SEPARATE ATTACHMENT
TO ITEM 11.1

LENNOX FORESHORE PARK

DRAFT MASTER PLAN

Ordinary meeting 24/3/11

(TEMPORARY) PUBLIC ART MURAL

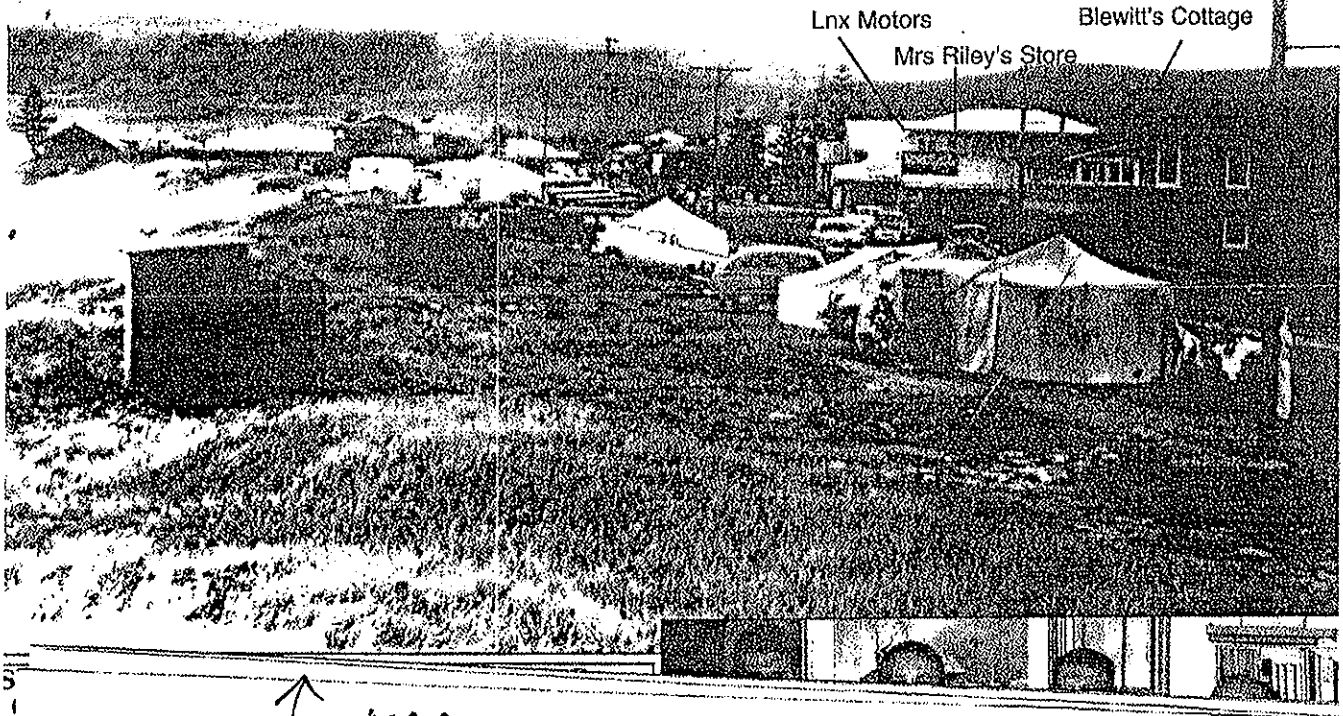
The genre for the proposed public toilets mural is fine for planters and smaller objects, but could be overwhelming in a large space.

What is the artist trying to say? ... 'LOVE FREE' on one concept, could be interpreted as advocating free love, possibly not ideal at public toilets.

Or is it big fish in a little pond? The images are of large fish, strange women with huge eyelashes, hearts, sunshine and surf.

- Greater abstraction, while retaining brilliant colours, might be more meaningful.
- Or perhaps an Aboriginal design, which would have to be executed by Aboriginal artists.
- Or a reference to Lennox being the meeting of cultures. Capt. James Cook and naturalist Joseph Banks noted in their diaries, when the Endeavour was sailing up Australia's East Coast in 1770, the appearance of Aborigines at Lennox Head. That reference is of national significance.

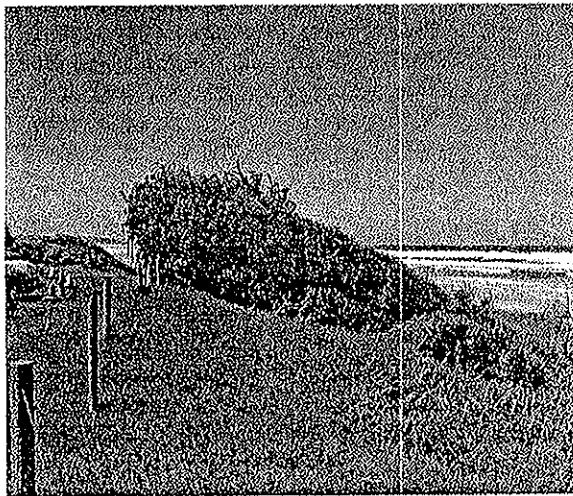
Establishment of Plantings - Norfolk Pines and Pandanus need low mowing barriers around them, at about 1000mm Diam and need mulching. The mowing barrier or something similar needs to remain around Pandanus for the life of the tree.

For plants listed at items 2] and 4] above, experience shows that windward i.e. North /South barriers at least 900mm high are required to properly protect plantings. A lot of people do not like shade cloth fencing but it is the cheapest effective barrier. If Lomandras (Mat-rushes) are planted at 900mm centres 500mm behind the fence, the barrier becomes more effective. Ideally, barriers built from timber, masonry or rock would be much better. They could incorporate other features e.g. artwork, and would give more colour and texture to the Park. All plantings should have applications of native plant fertilizer and be heavily mulched.
